GW - 32

**PERMITS,  
RENEWALS,  
& MODS**

**From:** Price, Wayne  
**Sent:** Wednesday, December 10, 2003 3:27 PM  
**To:** Dorinda Manncina (E-mail)  
**Subject:** Ciniza GW-032 Draft Permit

RE: February/March 2003 Progress Report  
Giant Refining Co., Ciniza Refinery GW-032 Discharge Plan

Figure No. 3  
Property Site Map  
Unconfined Storm Water Flow Direction

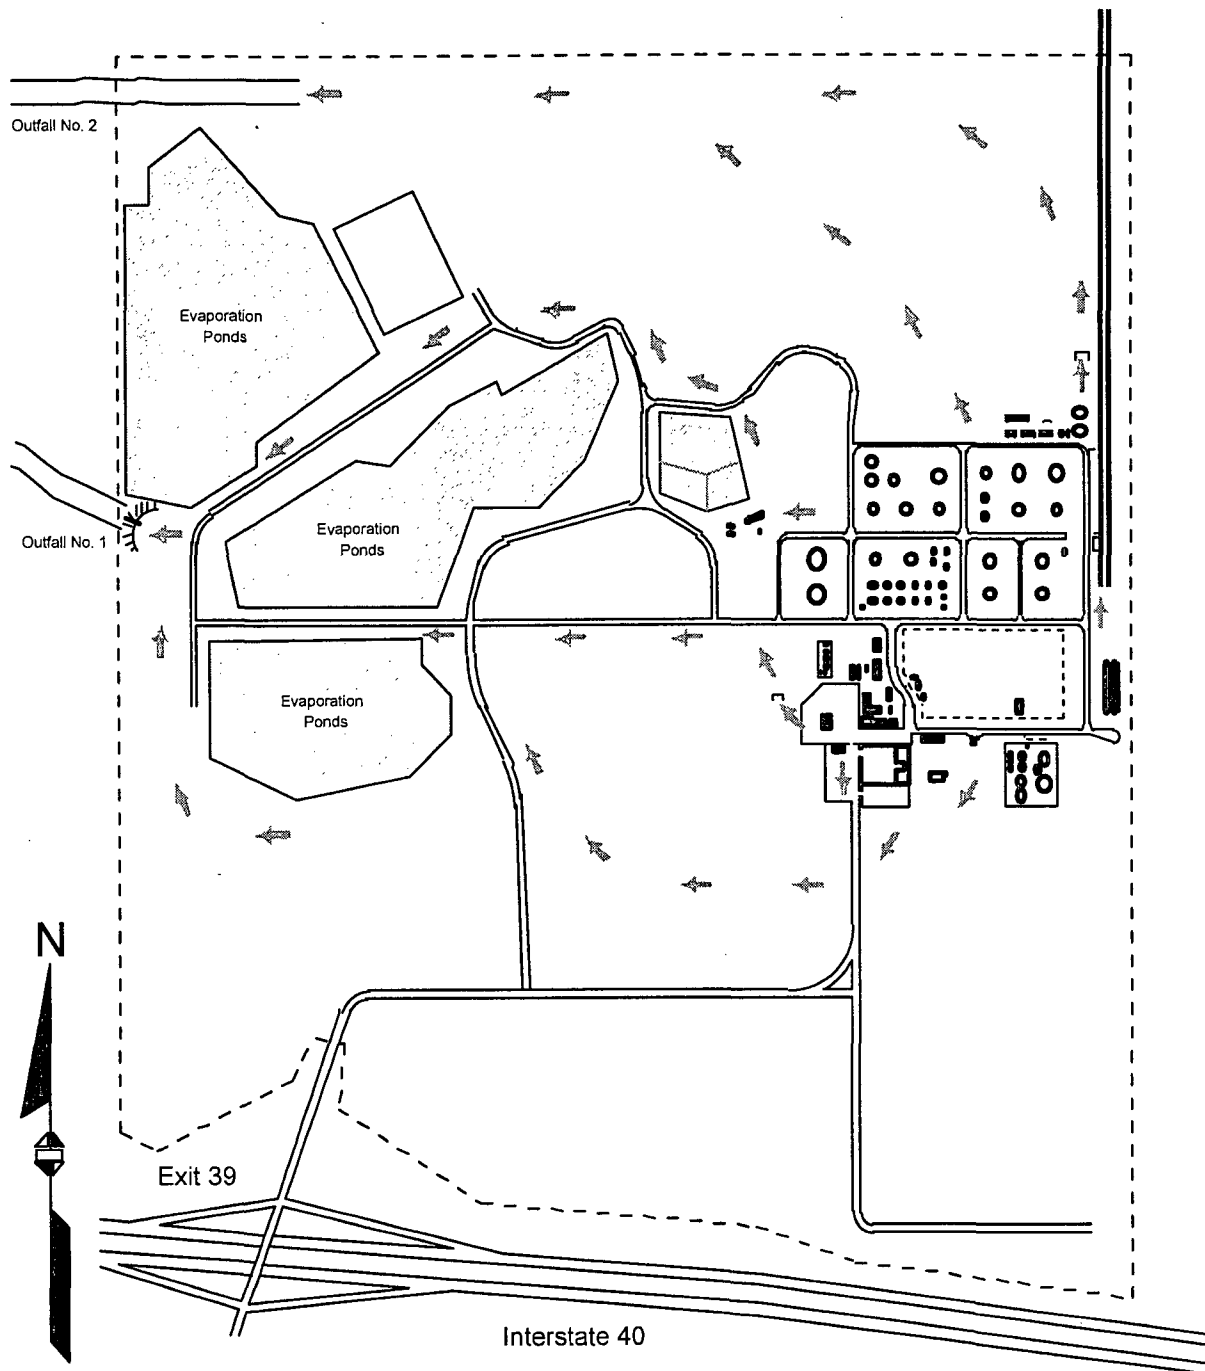
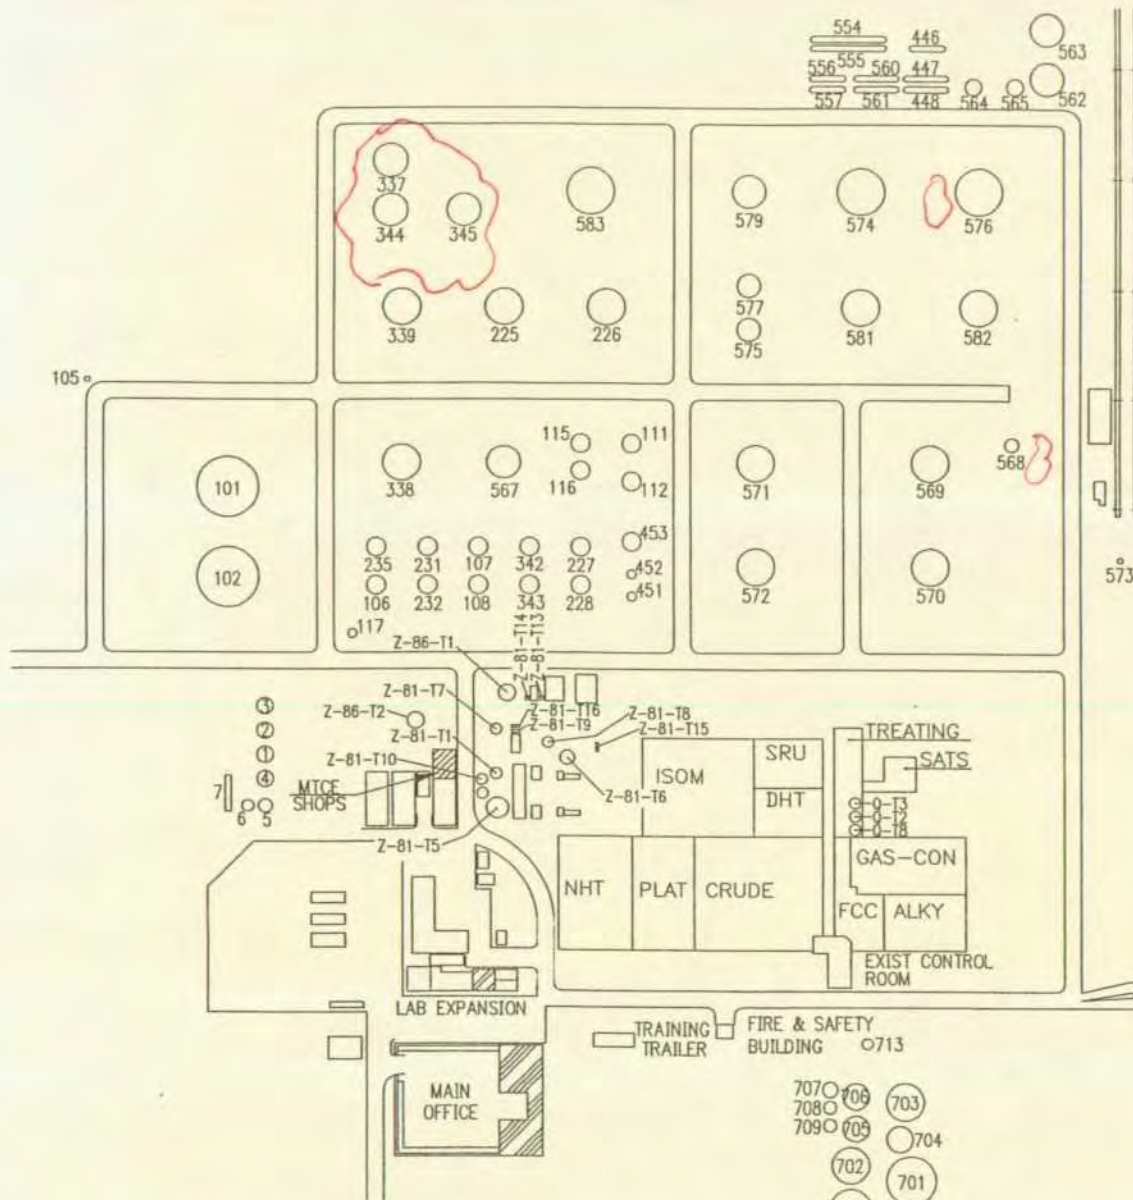
3. Investigate around old OW-20 high pH area - Again, Bill will provide boring data from the area where OW-20 was located. We made several attempts to drill another well in the same area, but encountered no water. The site map indicates both the old and new OW-20 locations. (Circled in orange on the map.)

5. Inspect the truck center – Giant's travel center has been notified and is available for inspection at your convenience.
6. Find out where OW-17 was located. Now closed, but was originally located w/in tank farm. Sonsela wells were closed in this area. – Ciniza has submitted this information previously, but will include it again in a future monthly progress report. The site map and tank farm maps are marked to show the area of interest. OW-17 was located near Tank 345. (Circled in red on the map.)

11. Giant wants to close OW-2 and OW-3 and replace with new ones – see #1 above (Circled in dark blue on the map.)
12. Giant does not want to monitor OW-1, OW-9, and OW-10. RCA wants these wells to be checked to make sure they are still under artesian conditions – We believe that OW-1 should be monitored annually as part of the groundwater discharge plan conditions, along with the 3 new well locations proposed in #1. OW-9 and OW-10 will be visually checked annually at the same time sampling is done to ensure continued artesian conditions. It may be appropriate to sample these 2 wells at 5-year intervals (i.e., as part of the Discharge Plan renewal). As of 2/6/03 these 3 wells have artesian flow. (Circled in light blue on the map.)
